BRISTOL, VIRGINIA INTEGRATED SOLID WASTE MANAGEMENT FACILITY

STAGE II LANDFILL GAS COLLECTION AND CONTROL SYSTEM EXPANSION

CONSTRUCTION PLANS

FEBRUARY 18, 2025
ADDENDUM 1: APRIL 7, 2025

DRAWING NO. E6

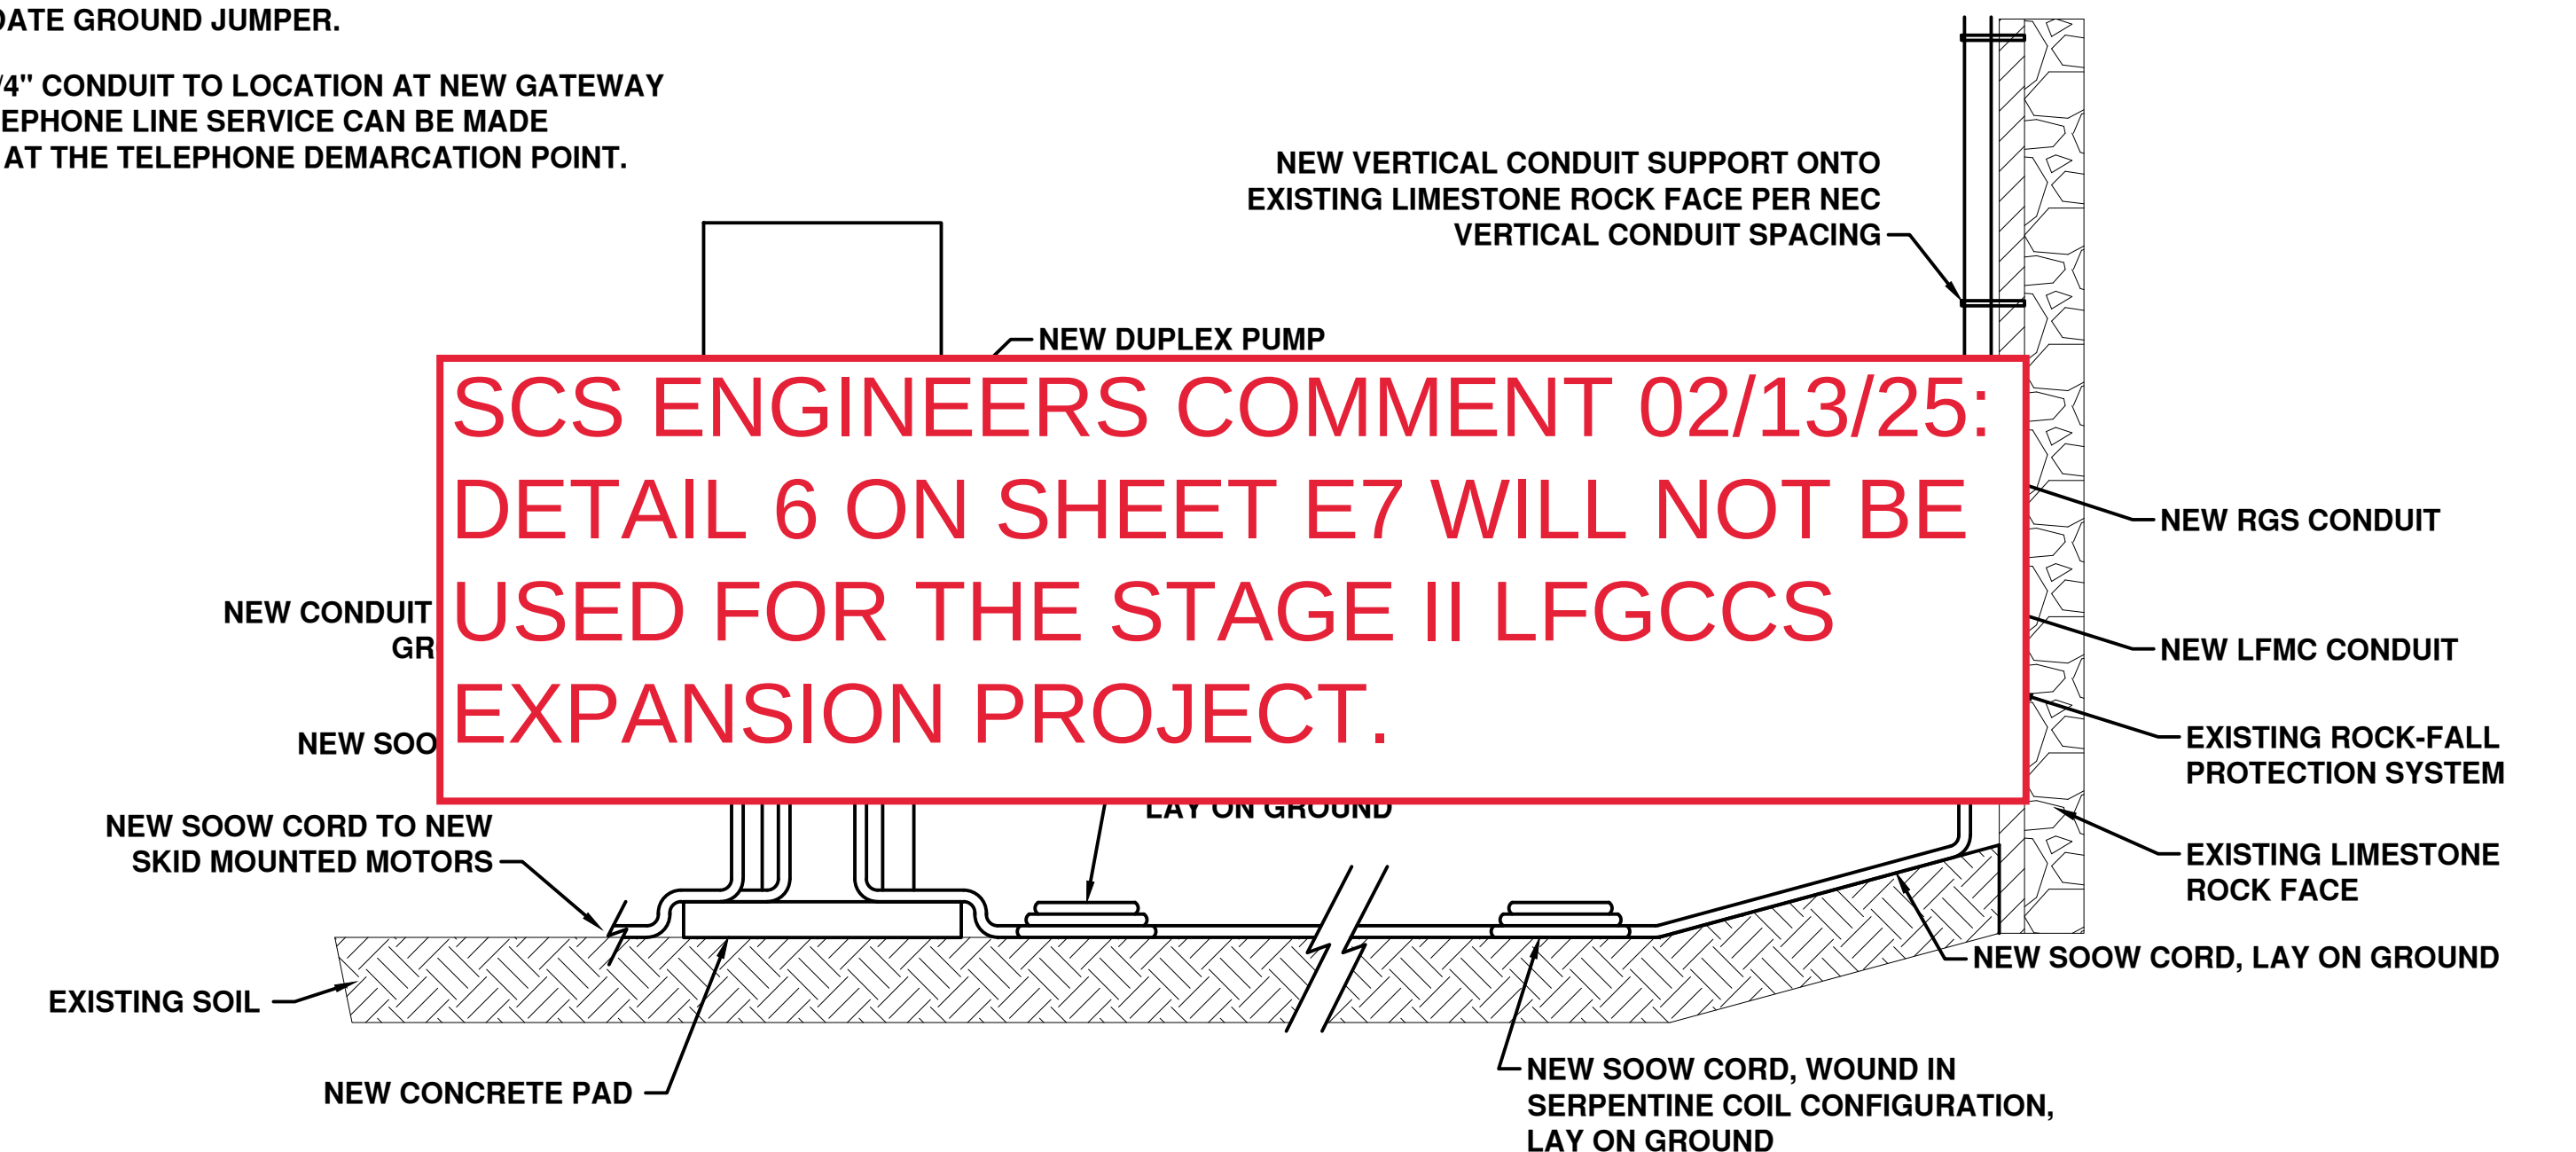
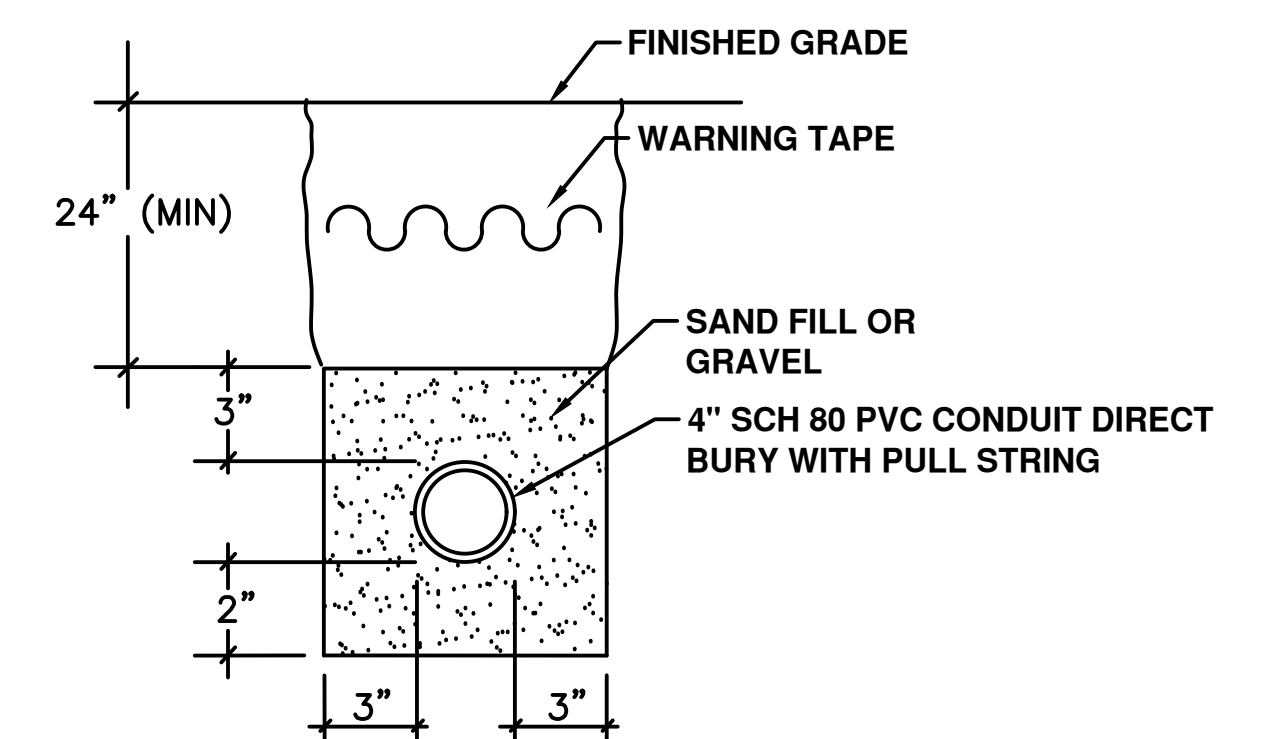
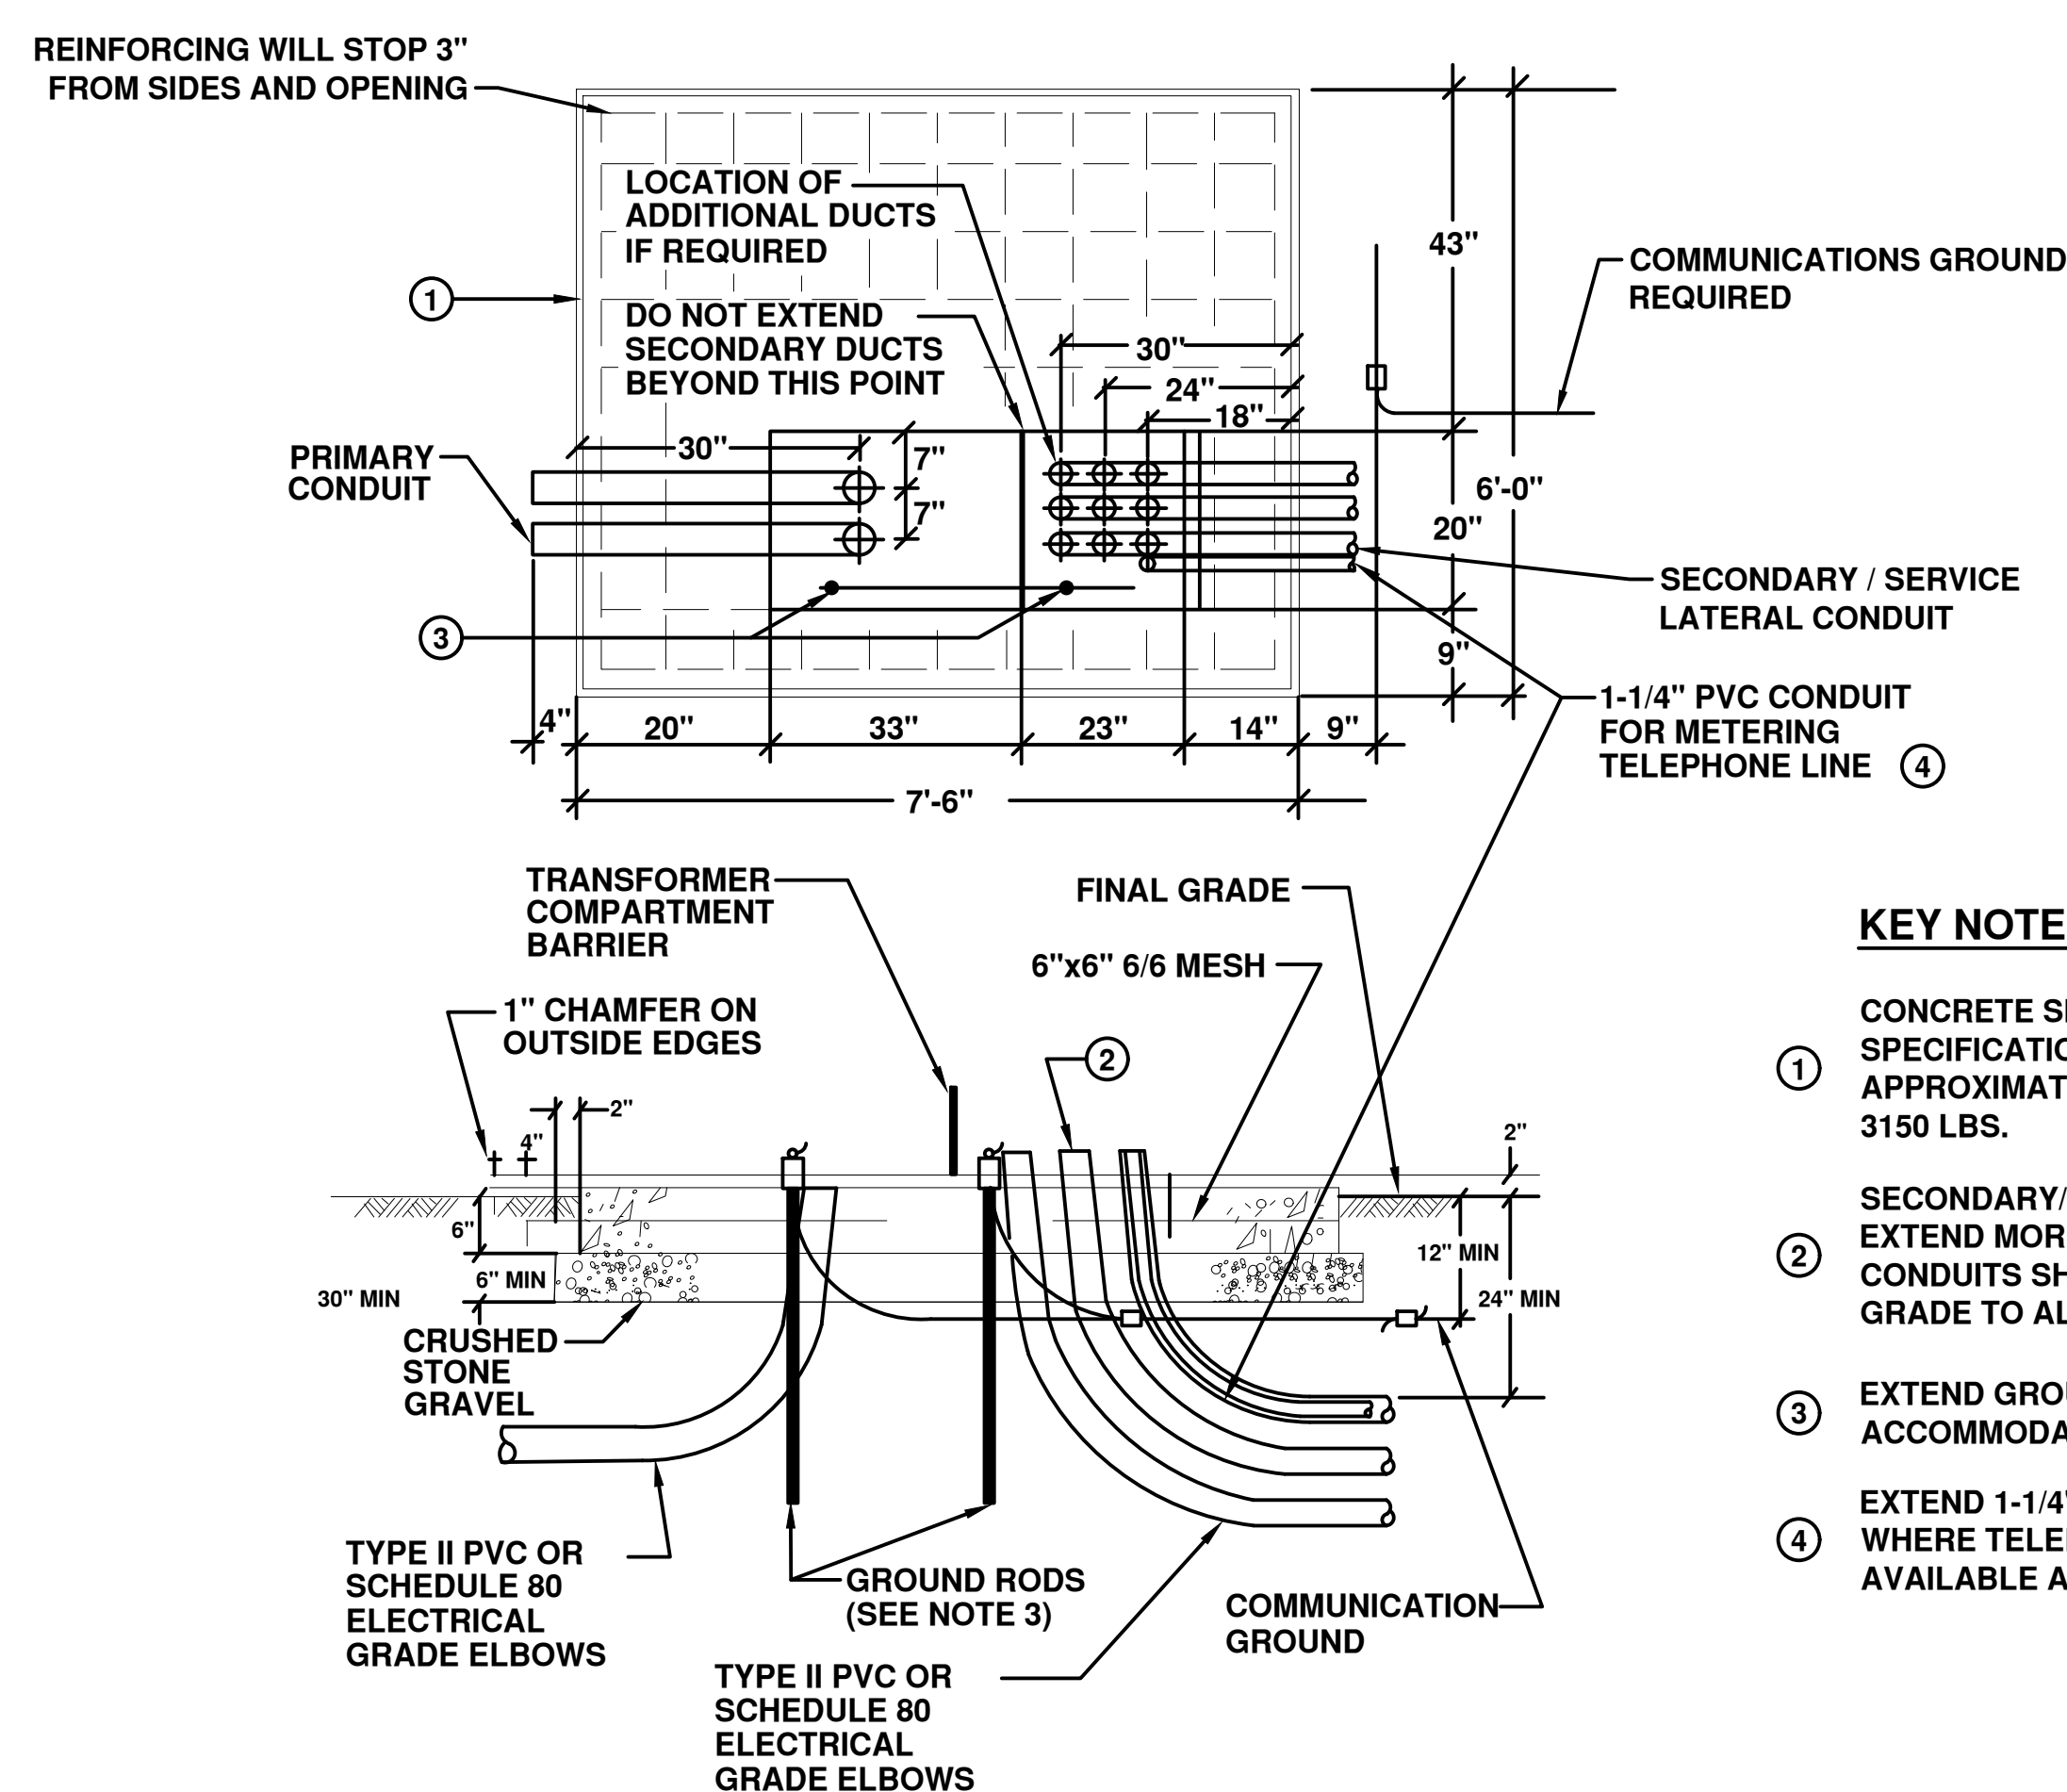
SCS ENGINEERS COMMENT 02/13/25:
DETAIL 6 ON SHEET E7 WILL NOT BE
USED FOR THE STAGE II LFGCCS
EXPANSION PROJECT.
